# CIBU connection Review

BT, BP & IRR AB/CO/MI 12December 2008

## 1<sup>st</sup> presentation: CIBU Failure in UJ33 *(Benjamin TODD)*

## 2<sup>nd</sup> presentation: Proposal cures on HW side *(Bruno PUCCIO)*

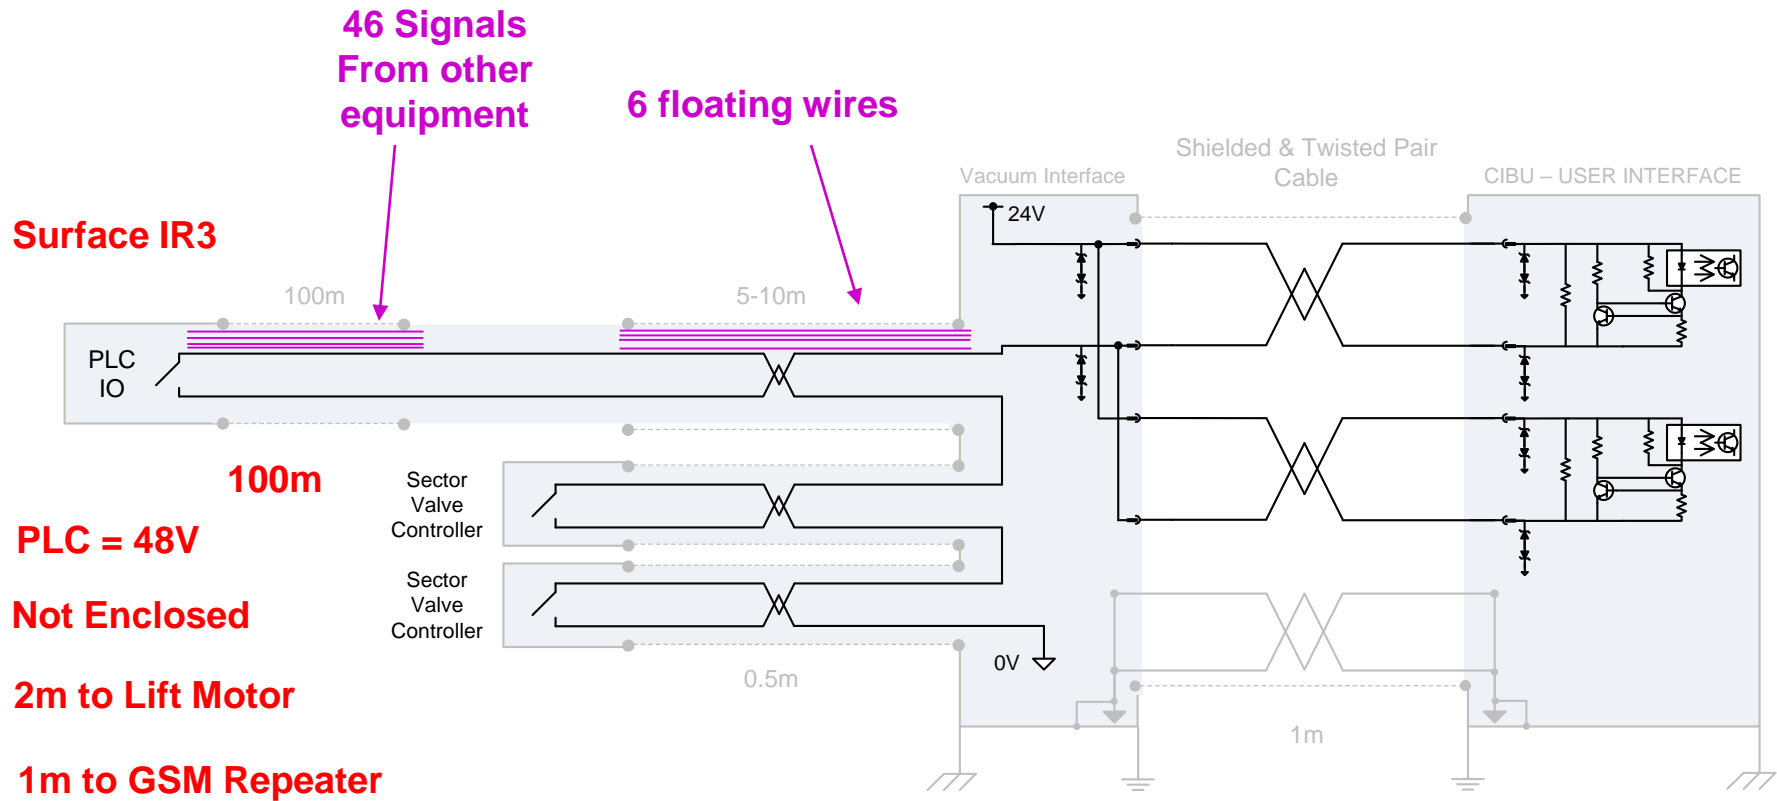
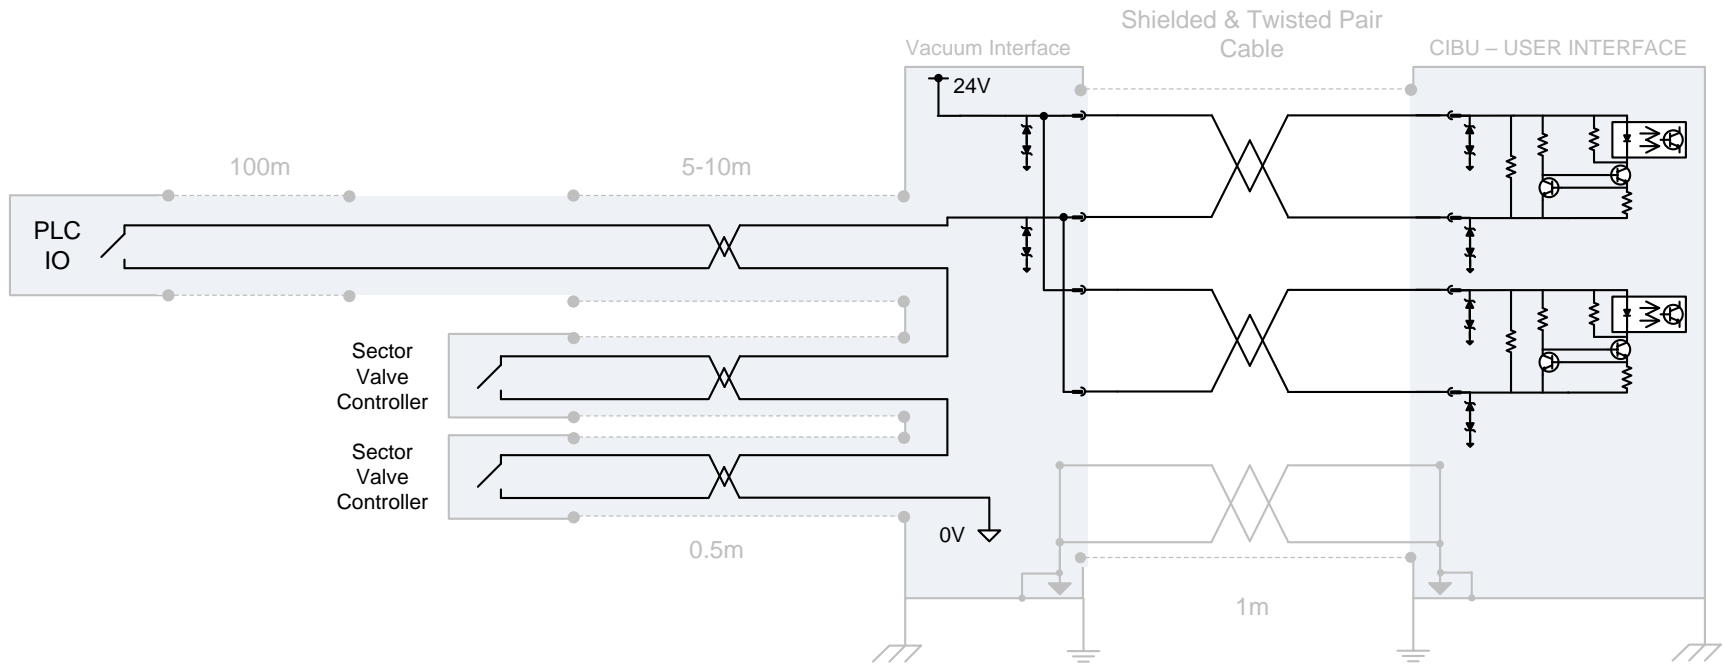
Between July and August  
EIS (Elément Important de Sécurité)

1. Added to Interlock Logic
2. EIS controlled by Access System (Personnel Protection Device)
3. Access System connected to BIS via Vacuum System

MI were not aware of this cabling change

**WHEN CONNECTED  
CIBU ALWAYS TRUE  
(next slides)**

Access – Connected Panel to Surface PLC incorrectly initially  
...took several attempts ...

## Presumed Failure

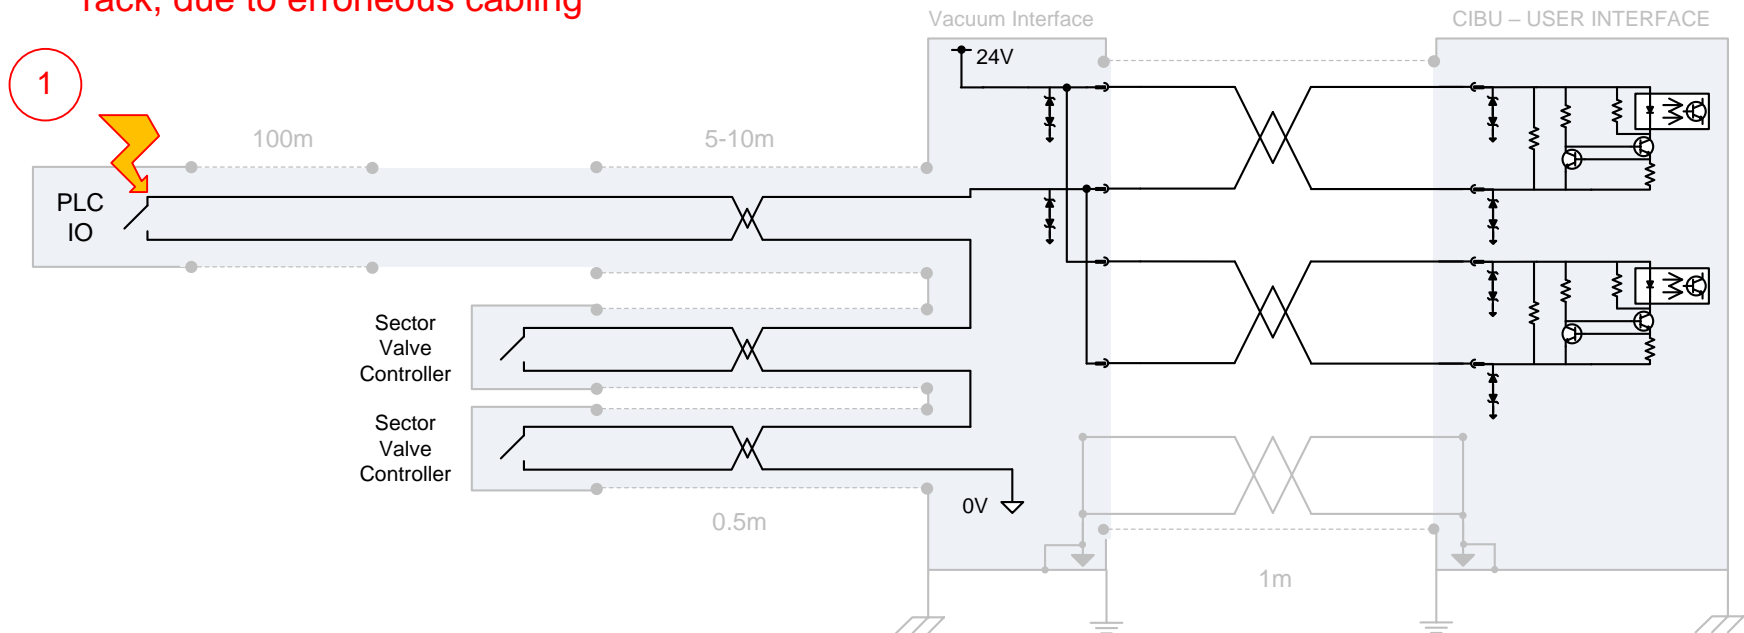
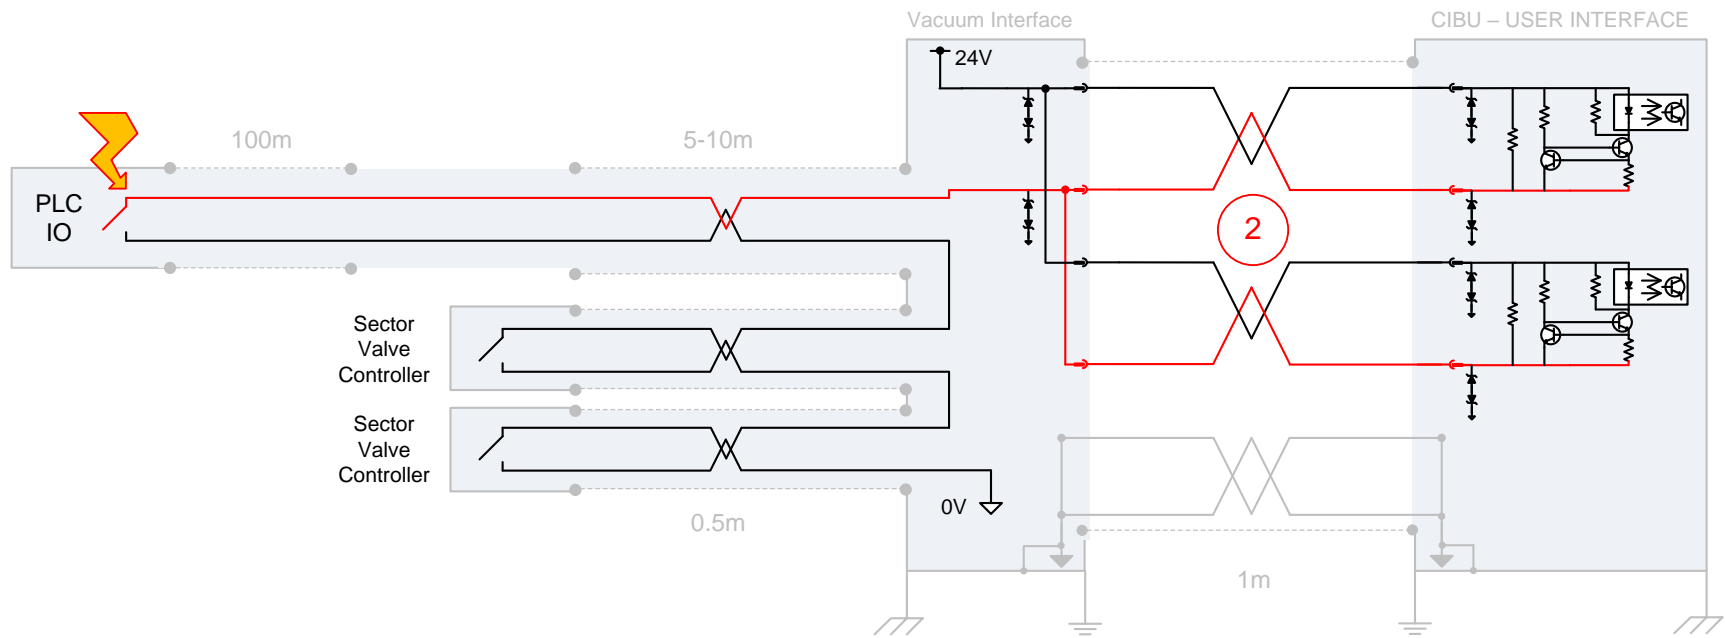
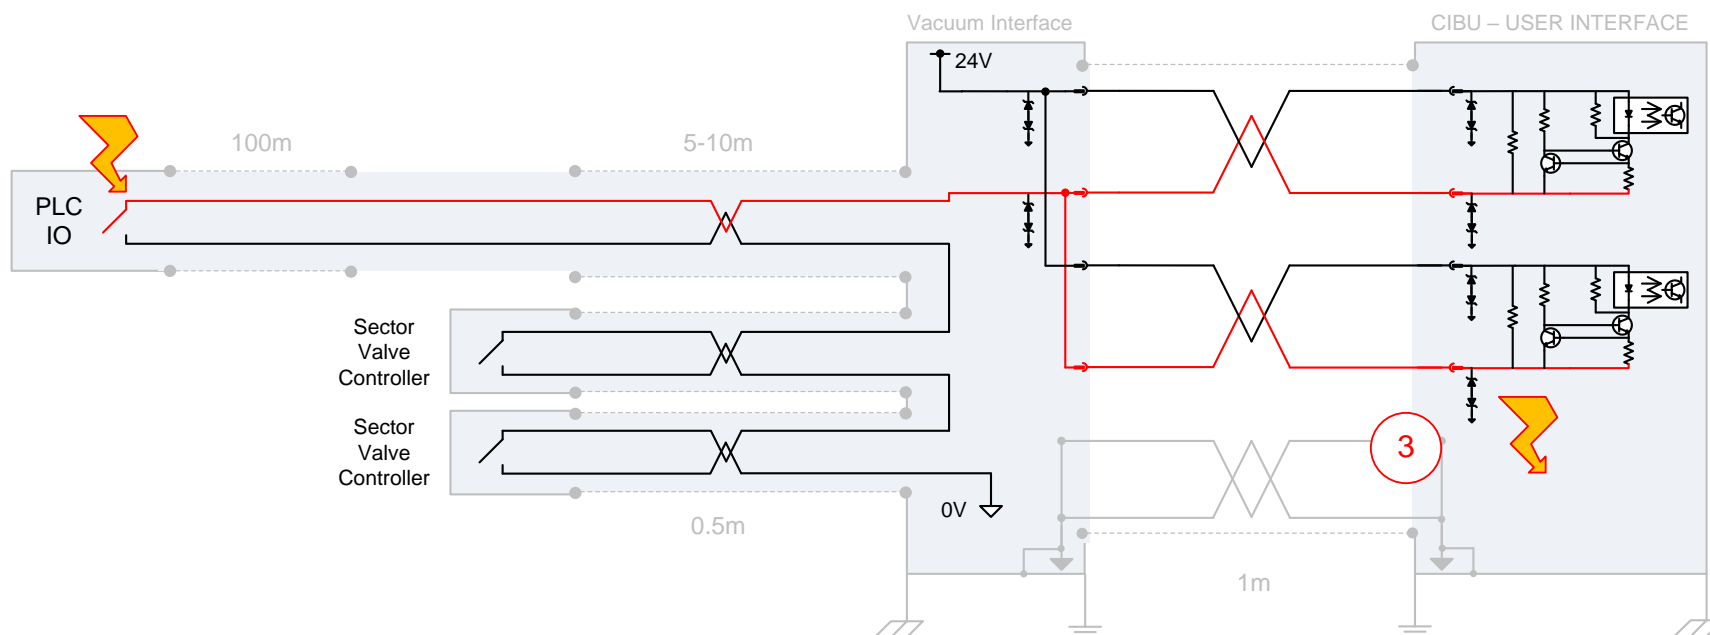
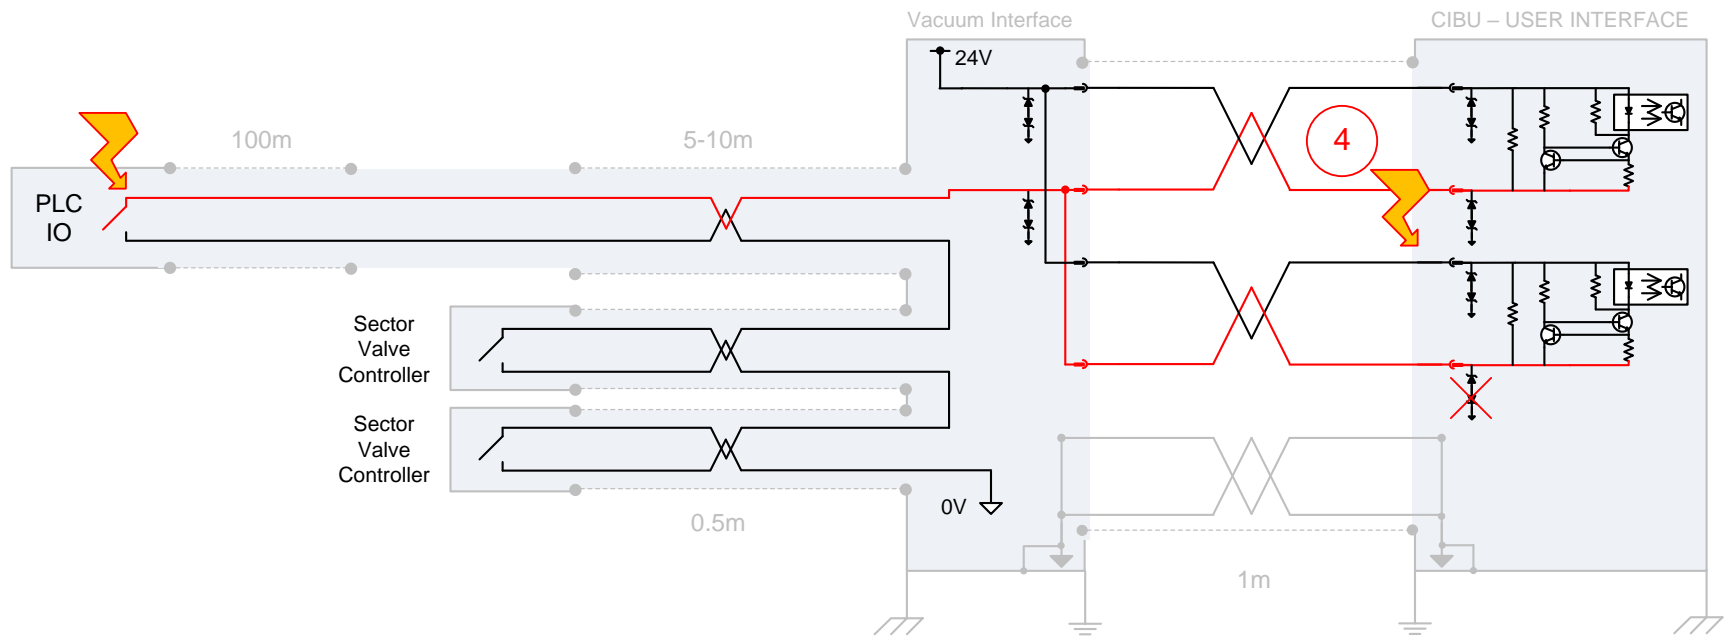
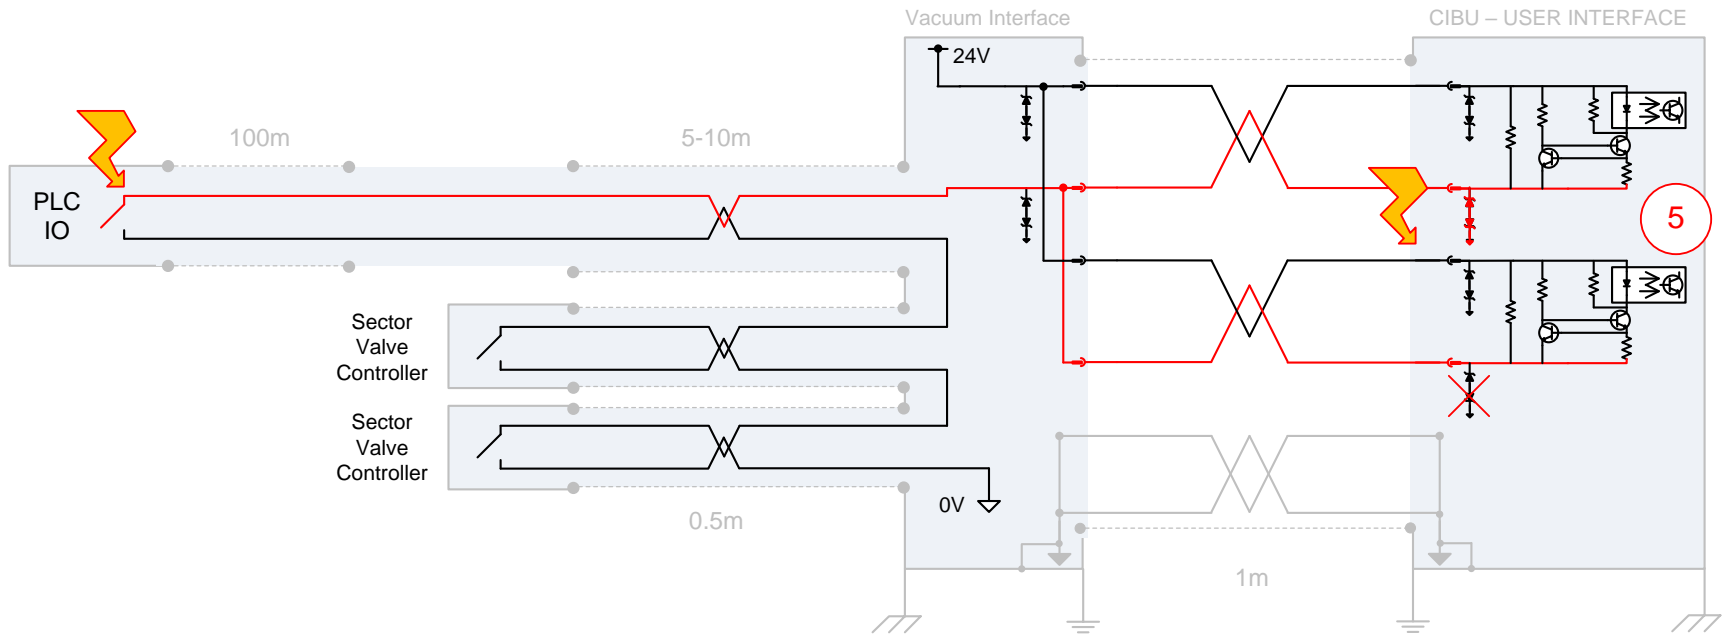
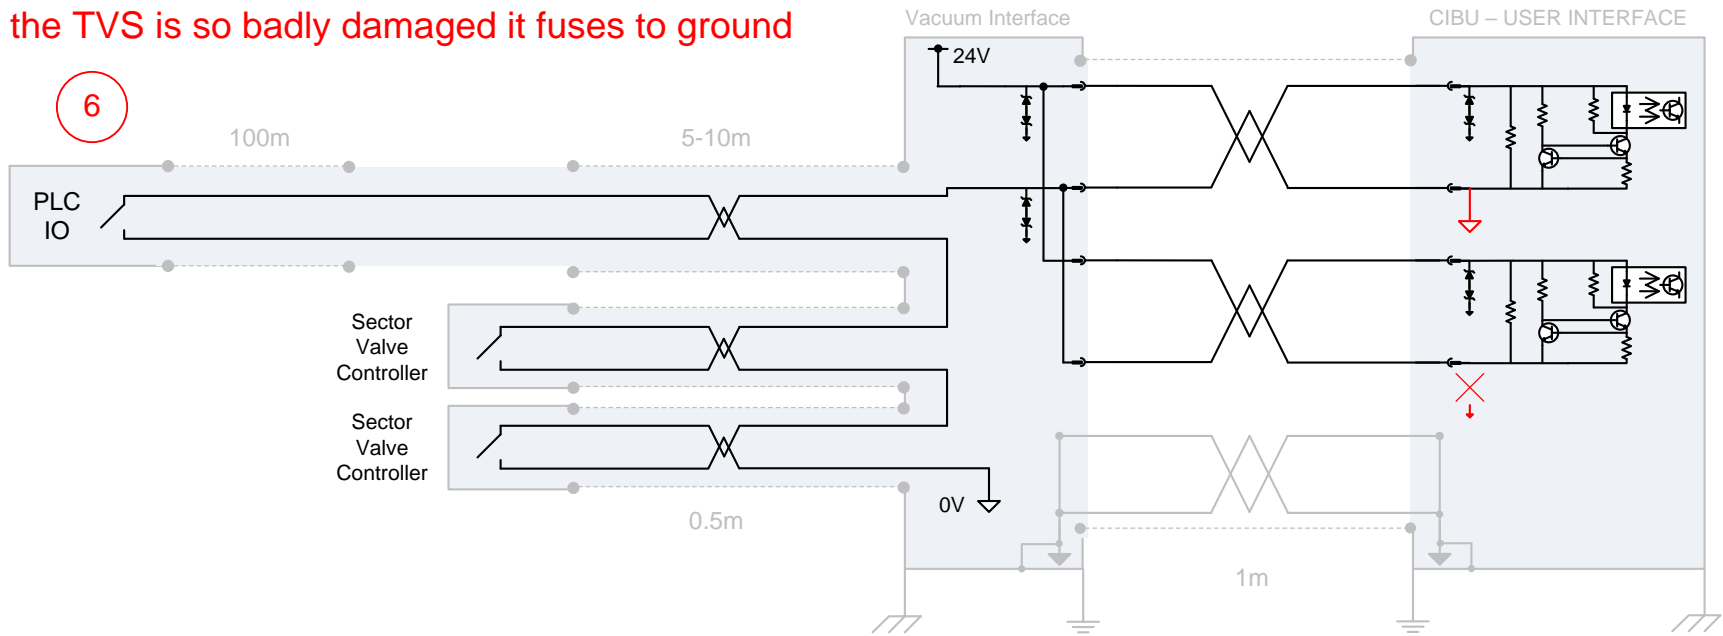
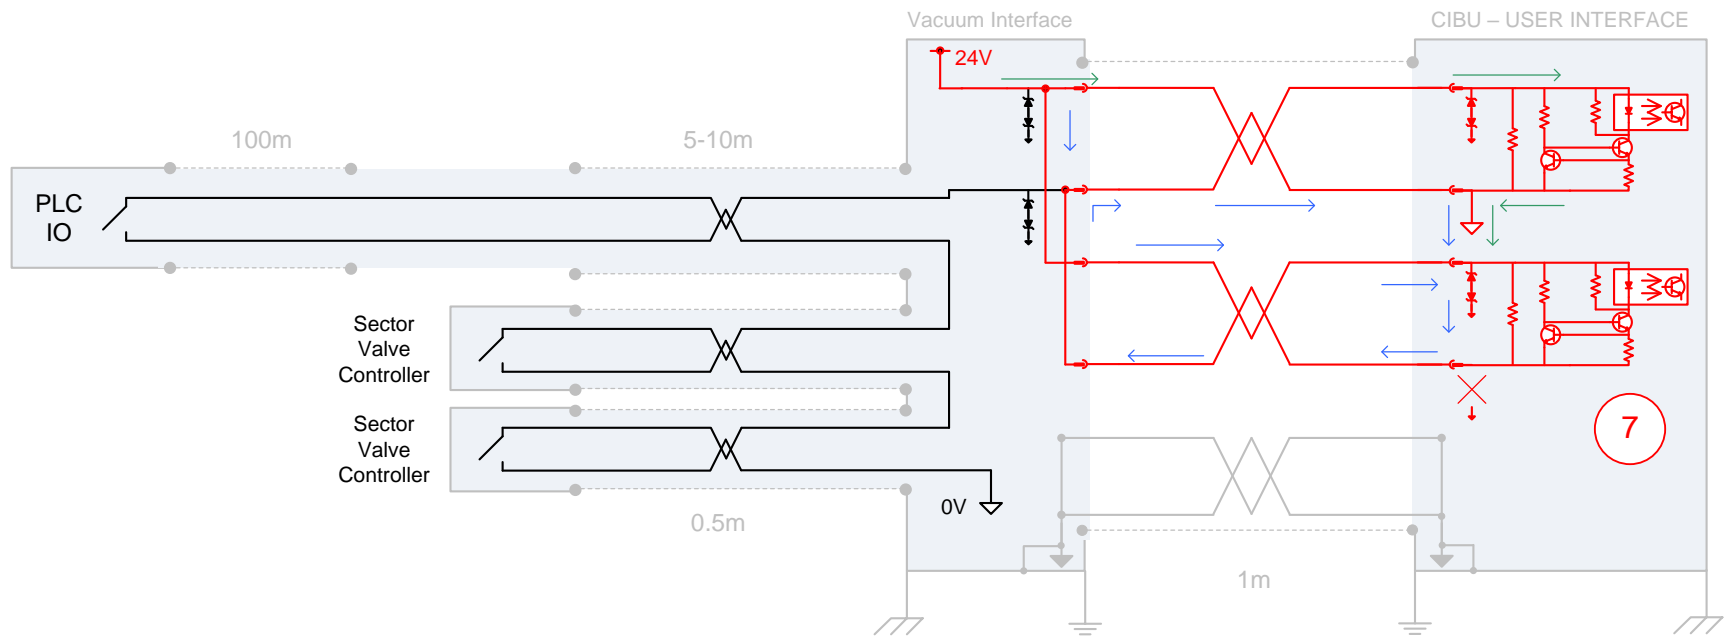
Is applied in the Access System PLC rack, due to erroneous cabling

2. This subjects the CIBU negative current loop to an excessive voltage (48V)

3. The Transient Voltage Suppressor (SM6T30CA) Clamps the voltage and dissipates the energy

4. Experiments show that after 1-2 seconds the TVS will fail, this TVS fails open-circuit  
The 'A' loop TVS now absorbs the excess

5. 1-2 seconds later this TVS fails short-circuit

6. The fault is discovered in the ACCESS system and is removed

But the TVS is so badly damaged it fuses to ground

7. At this point both USER PERMIT A and B are stuck TRUE as current flows to ground through A (green) and B (blue) using the damaged TVS
